# KETCHIKAN - KNUDSON COVE PARKING LOT EXPANSION PROJECT NO. K-31171 (67644)

## "As-Built" Plans

Contractors: Wyman Construction  
 Proj. Engr.: D.F. Robbins  
 Began: 10-2-85  
 Complete: 1-31-86

**PLAN LAYOUT**  
 1" = 20'-0"

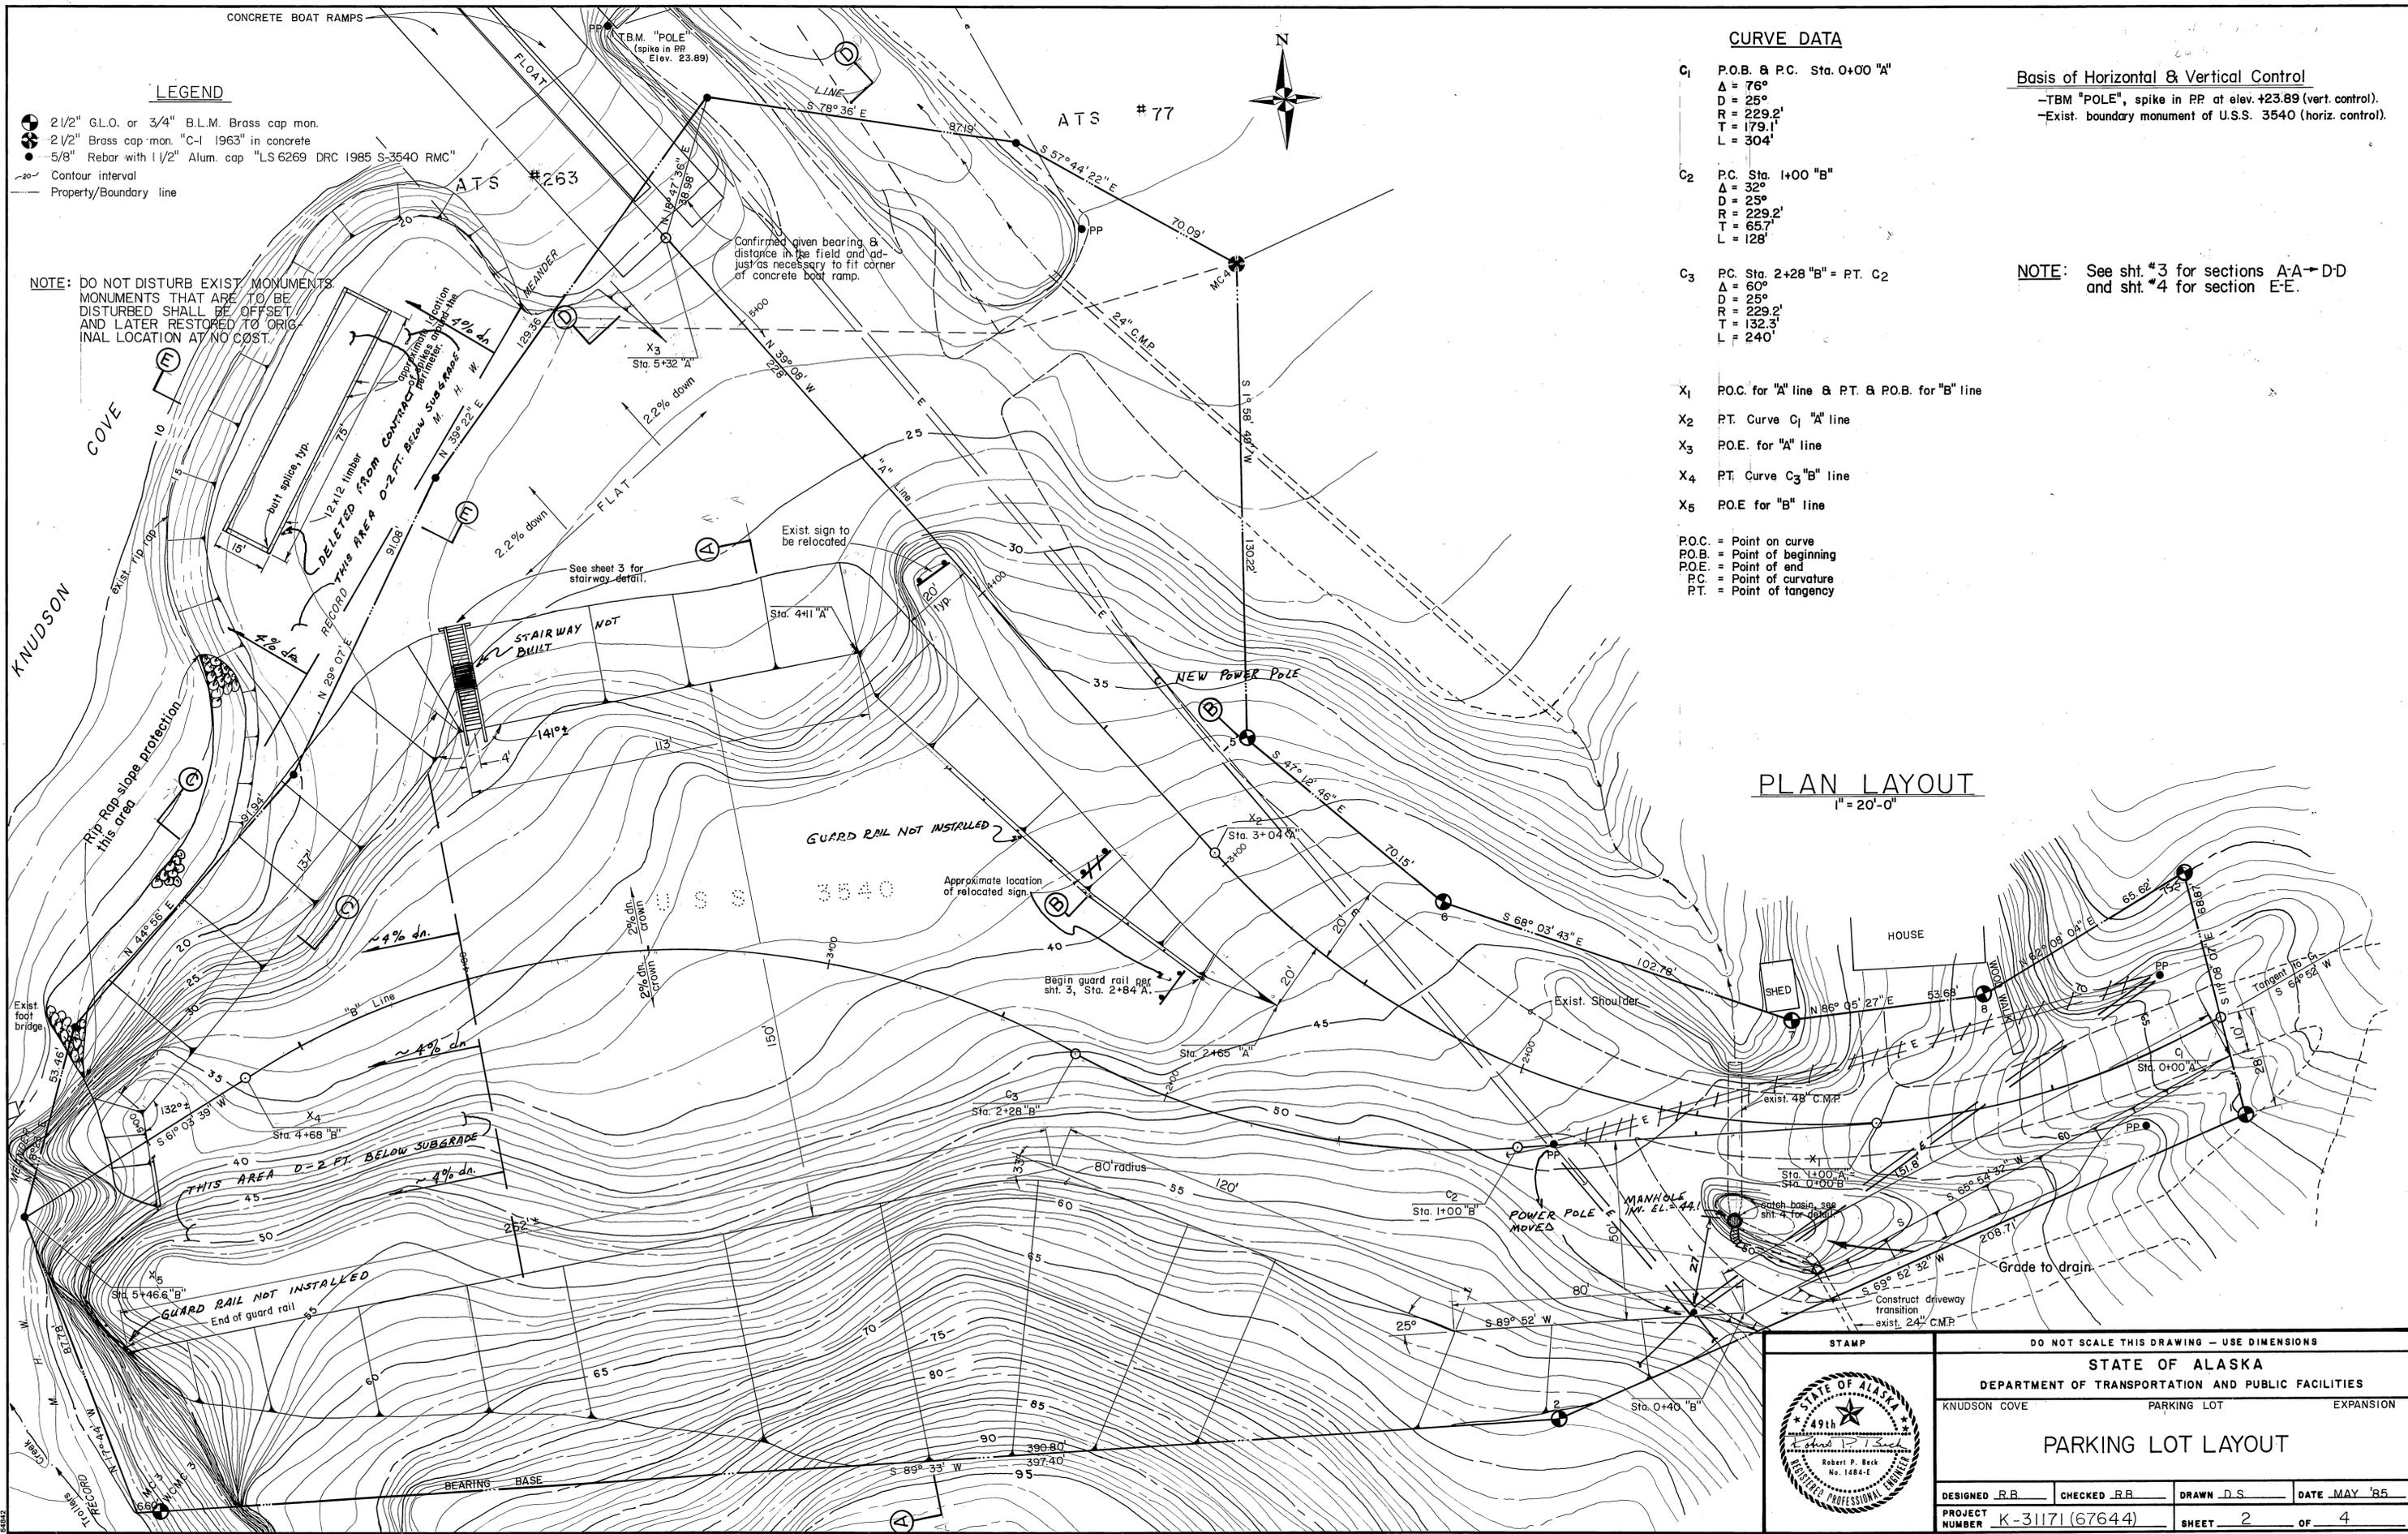
Confirmed given bearing & distance in the field and adjusted as necessary to fit corner of concrete boat ramp.

STAIRWAY ~ ELEVATION  
1/2"=1'-0"

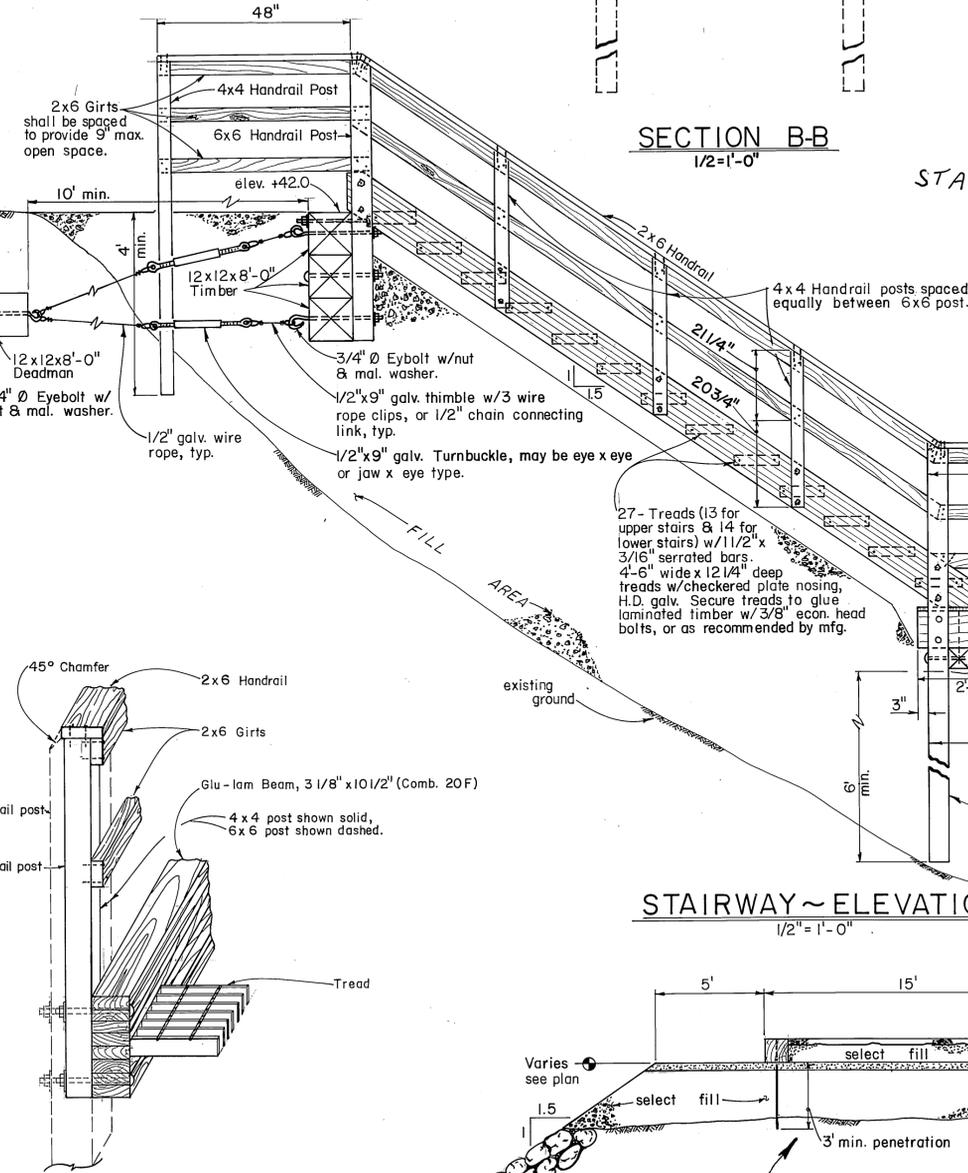
STAIRWAY NOT INSTALLED THIS PROJECT
